MEMORANDUM

To: Development Review Board
From: Mary O'Neil, AICP, Principal Planner
Date: May 1, 2018
RE: ZP18-0757CA; 131 Lakeview Terrace

Request: Addition and renovation to historic single family home.

2 **ELEVATION - WEST**
1/8" = 1'-0"

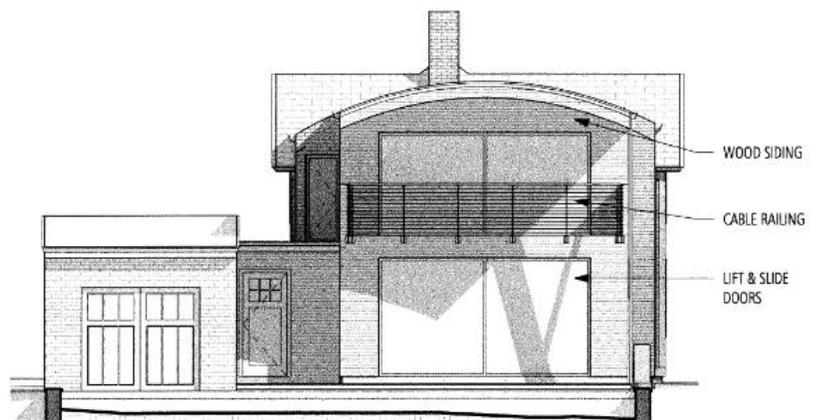
The orientation of the principle building will remain as existing. The proposed addition extends westerly, in the rear as is typical of most residential additions. That westerly building elevation provides another articulated face toward Lake Champlain.

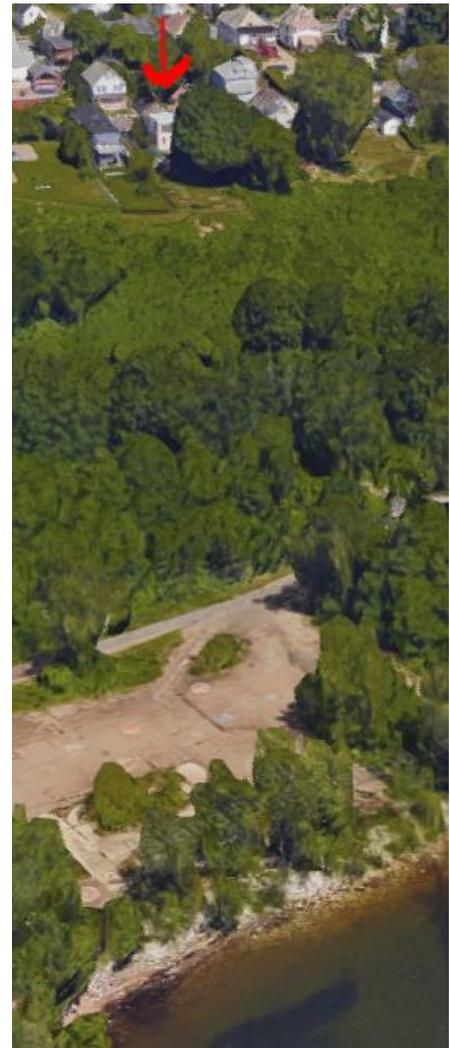
The addition, although large, is located behind the principle structure and will remain largely out of view from the public street. The height does not exceed that of the existing historic home. **Affirmative finding.**
